IN THE DRAWINGS:

Please cancel the drawings now on file, and please replace by substituting the new set of drawings for FIGS. 1 to 11 attached hereto, as "Replacement Sheets."

Fig. 3a

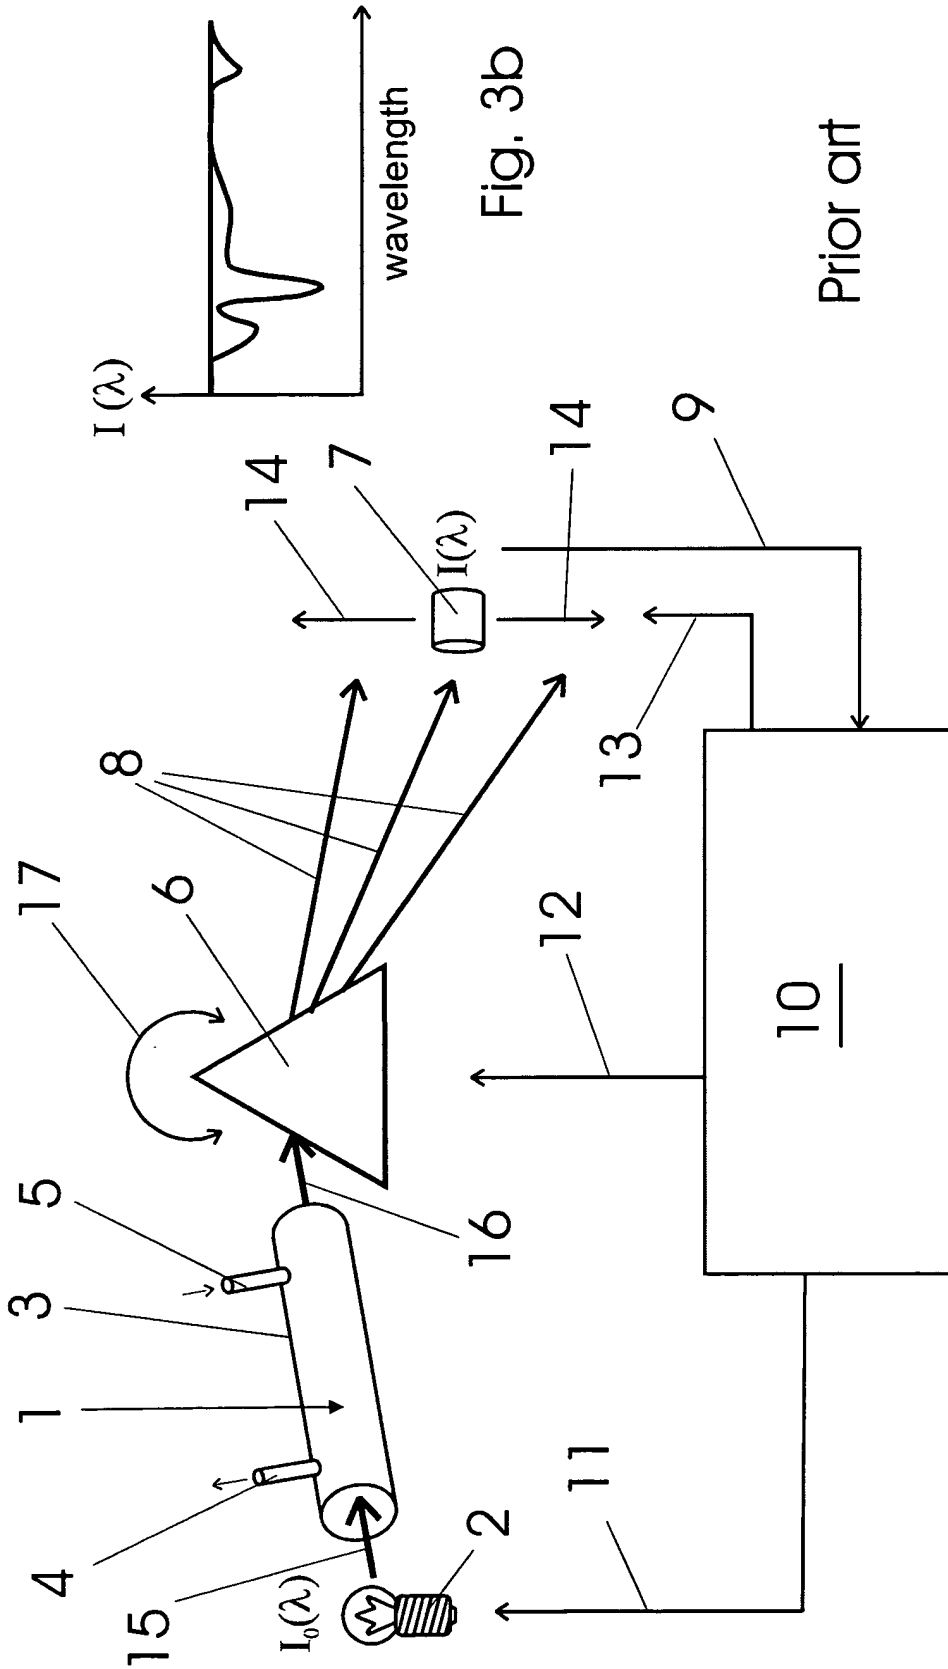
These new drawings have eliminated the foreign word "und." These new drawings have used "Prior Art" instead of "State of the Art" in FIGS. 3a, 3b, 10a and 10b.
